Re: Arklow Bank Wind Park Development Phase 2. OA27-319864 Sure Partners

Summary. I made an observation on the original application and am responding to the additional information submitted. This is extremely close to the shore, 6Km at the North end and 8Km from Brittas Bay(BB). With an arc of view of 105 degrees from BB it is exceptionally visually intrusive. The changes made have not mitigated this in any meaningful way. Other European countries have not allowed such visual intrusion especially in such attractive locations as BB.

PROJECT DESIGN OPTION 2 - WIN PARK LAYOUT

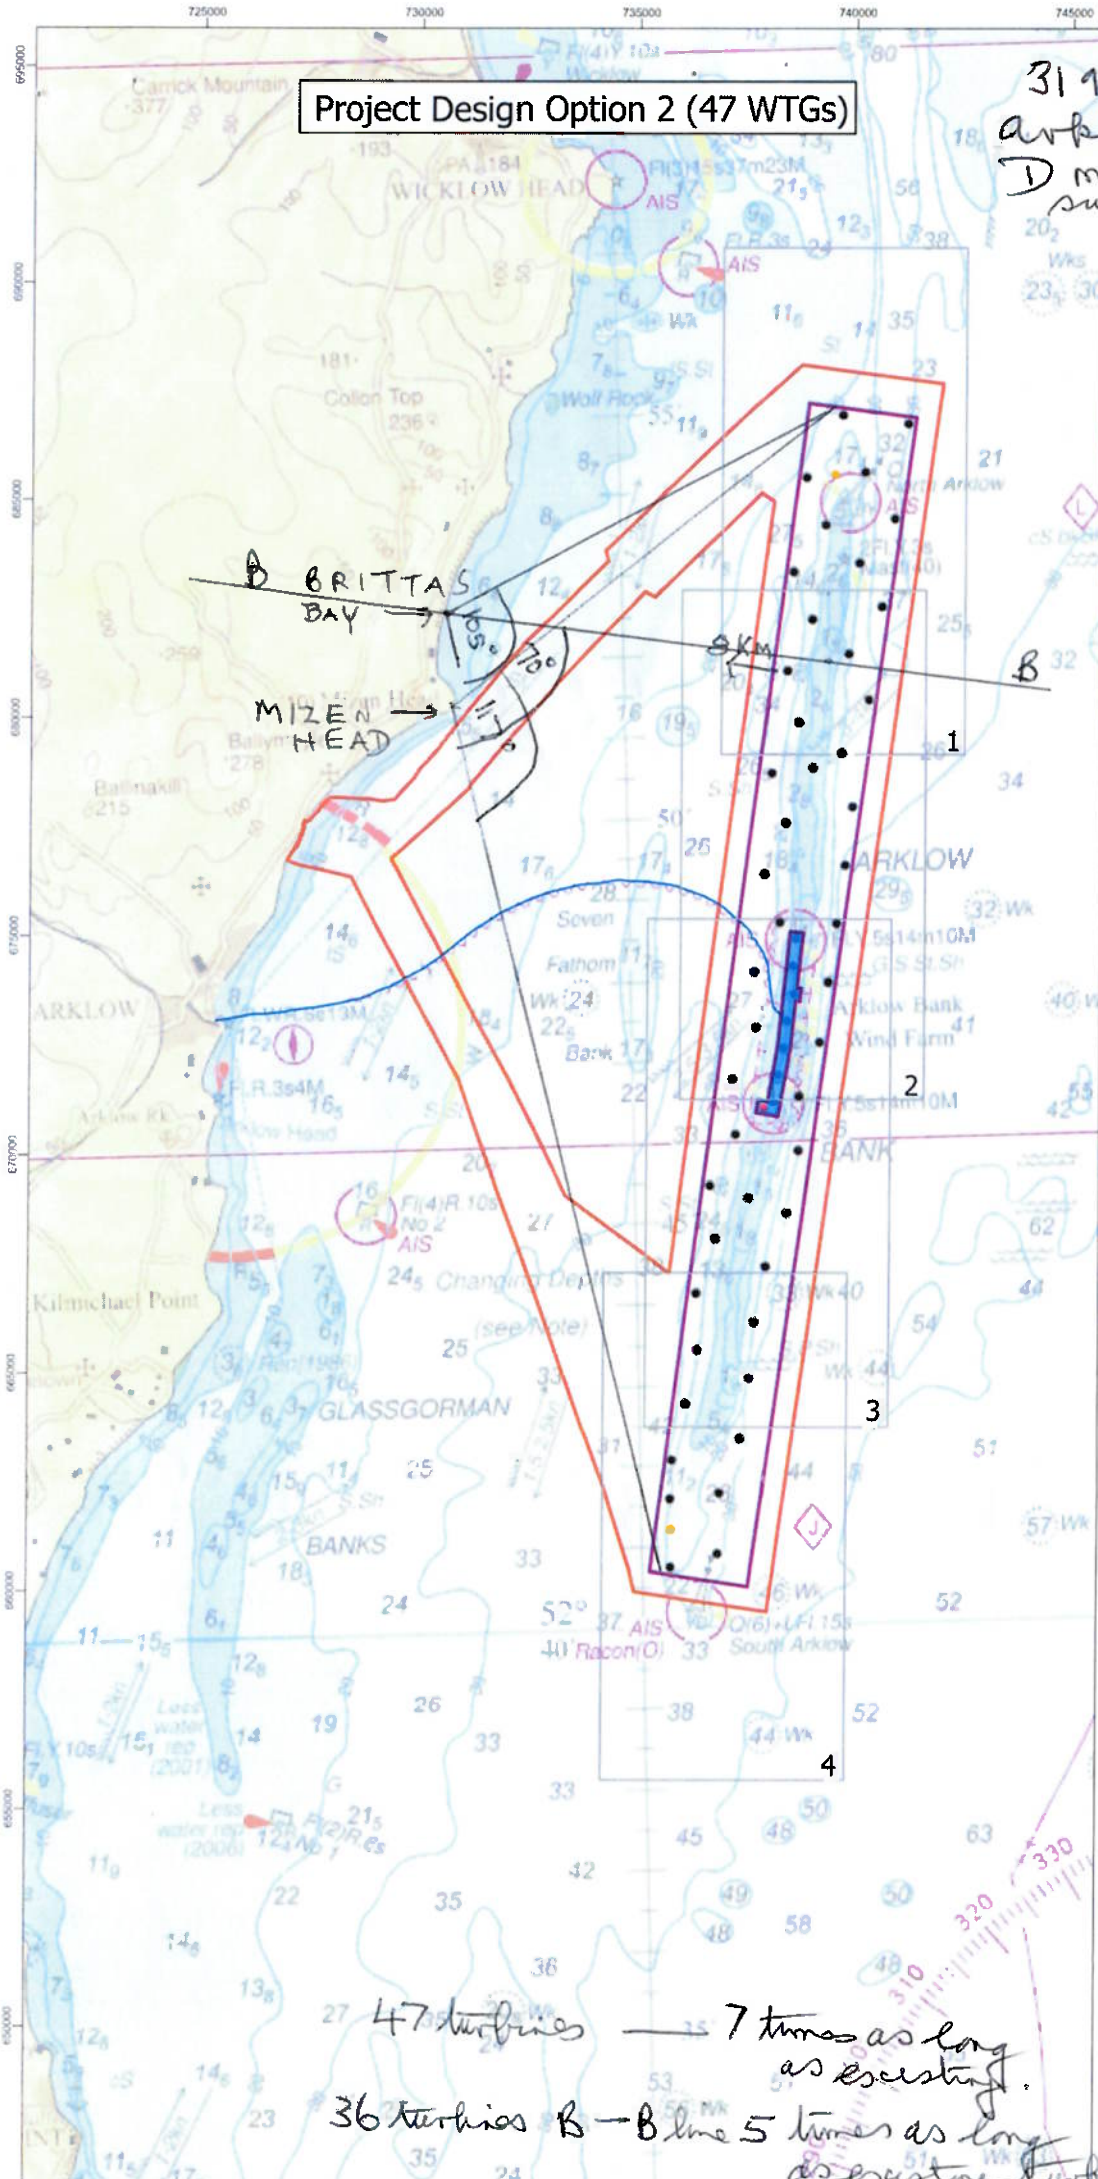
11 turbines at the Northern end, closest to shore, need to be cancelled to the line BB in Appendix 1, leaving an Arc of View of 70 degrees. This reduces the number of turbines to 36 and thus reduces the visual impact while allowing National Renewable energy targets to be reached.

The 11 Northmost Arklow turbines should be deleted thus reducing the Arc of View to 70 degrees at BB and reducing the visual intrusion to the beaches North of Arklow where it is so close to the coast. This would still provide 36 turbines enabling National Renewable targets to be reached. The developer partly justifies his tiny changes based on the view of the existing turbines. However his proposals are 7 times longer and double the height which is entirely different.

REDUCED FROM 105° TO 75° FROM LLANDUDNO AND 8.5KM FURTHER FROM ANGLESEA AONB.

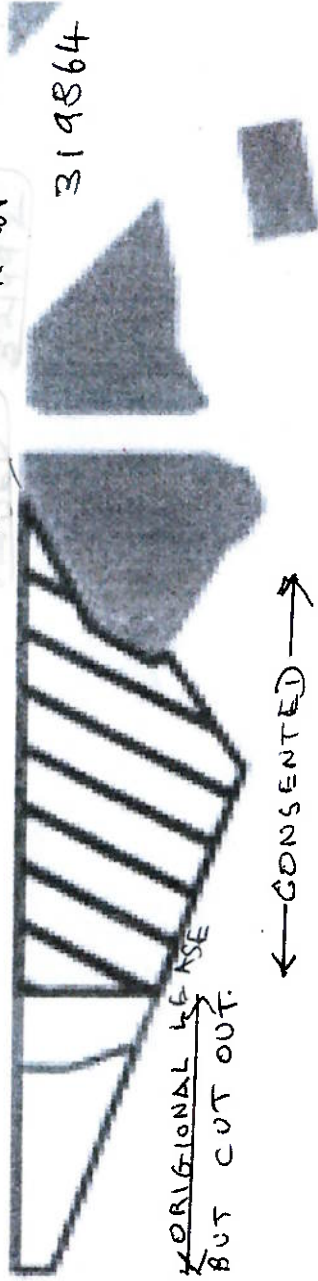
At Awel-Y-Mor, Llandudno the arc of View was reduced from 105 to 75 degrees, cumulative with other wind farms, and more than 10Km offshore. Awel-Y-Mor was consented 2024.

APPENDIX 3B RAMPION 2 REDUCTION

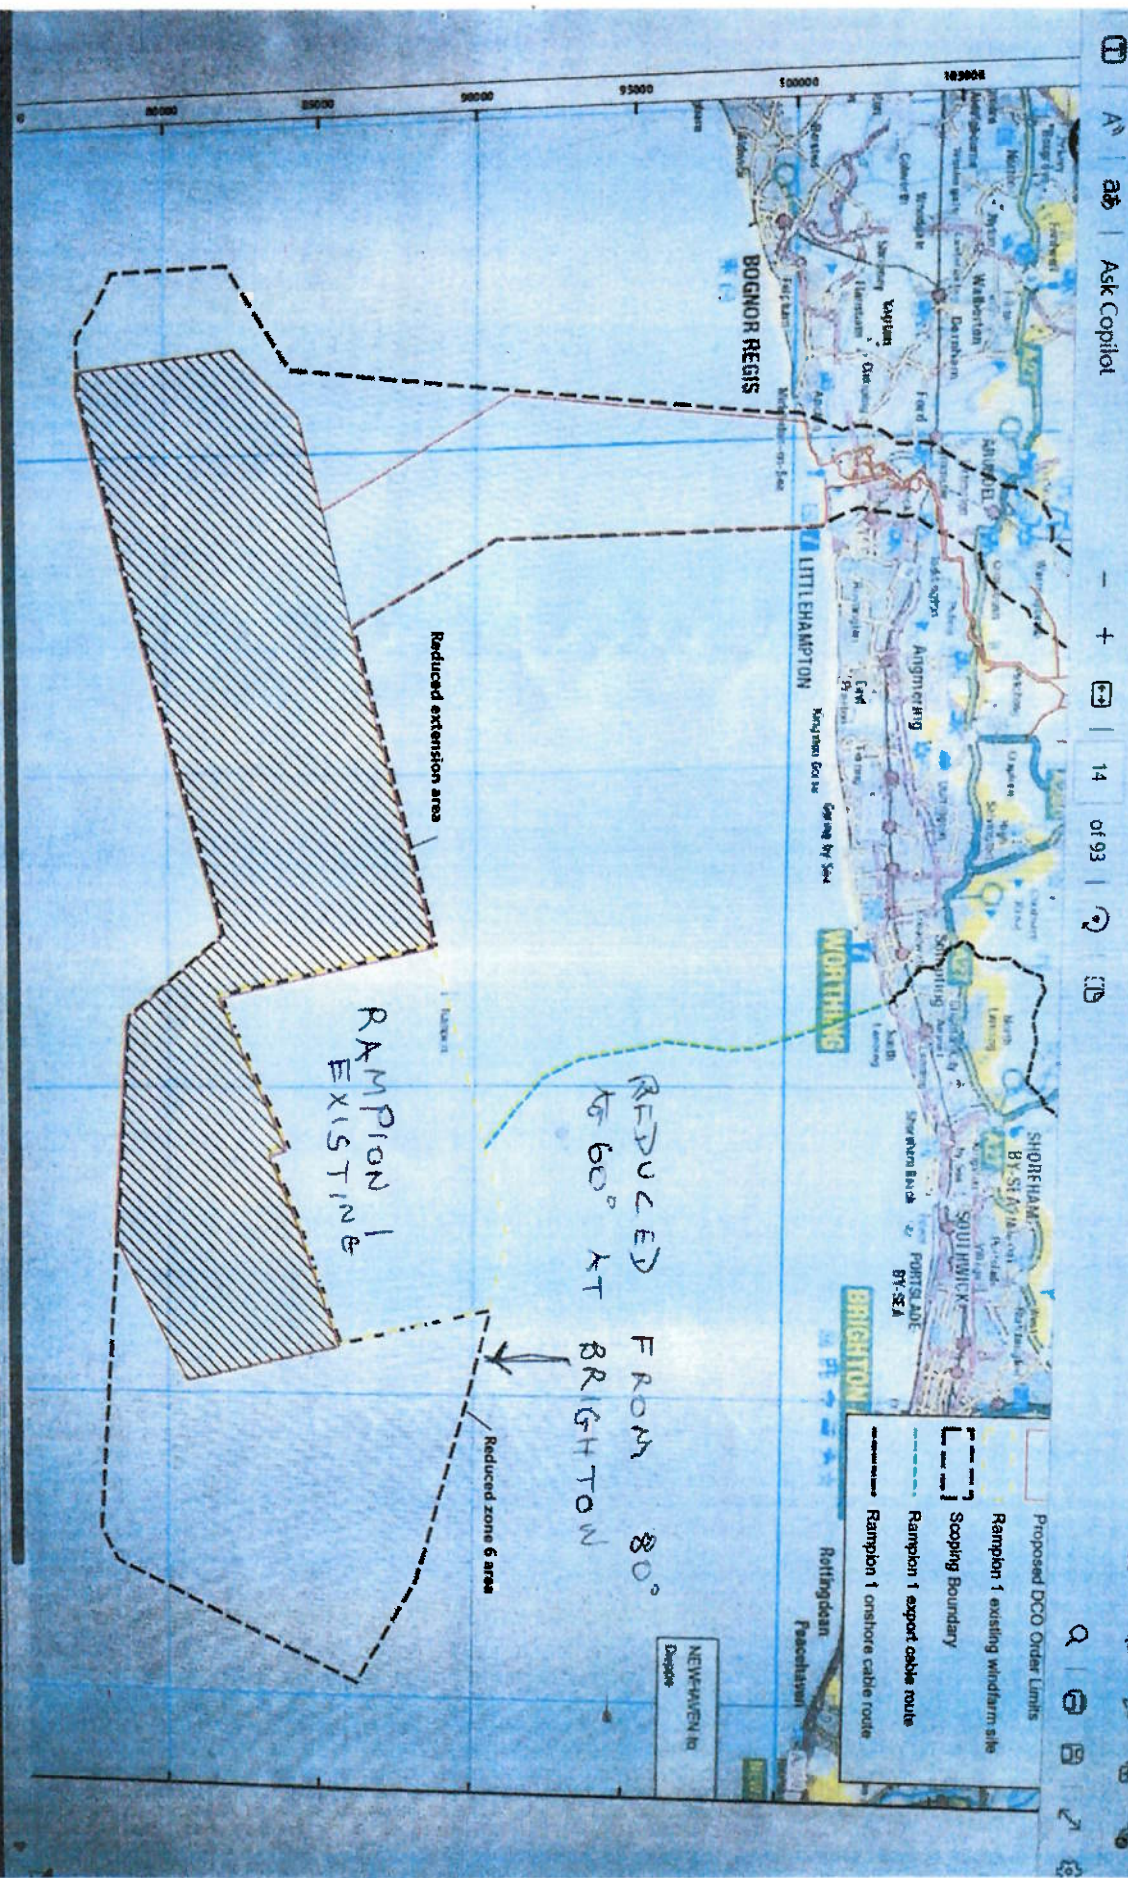
Rampion 2, off Brighton reduced from 80 to 60 degrees cumulative with Rampion 1 an existing smaller wind farm. Consented April 2025. Both applications from RWE and both now occupying less than the lease area. Detailed maps of this reduction in Appendix 3A & 3B. Both Planning Inspectors Decisions note this reduction per Appendix 4A & 4B. **Both Inspectors emphasise that the array & turbine number reduction is the main mitigation measure.**

Rampion 2 is further from the coast than Arklow Bank windfarm is from Brittas Bay and the angles of view were reduced to 60 degrees during consultation. My proposal that the 11 most Northerly turbines be deleted reduces the angle to 70 degrees and it is considerably closer than Rampion 2.
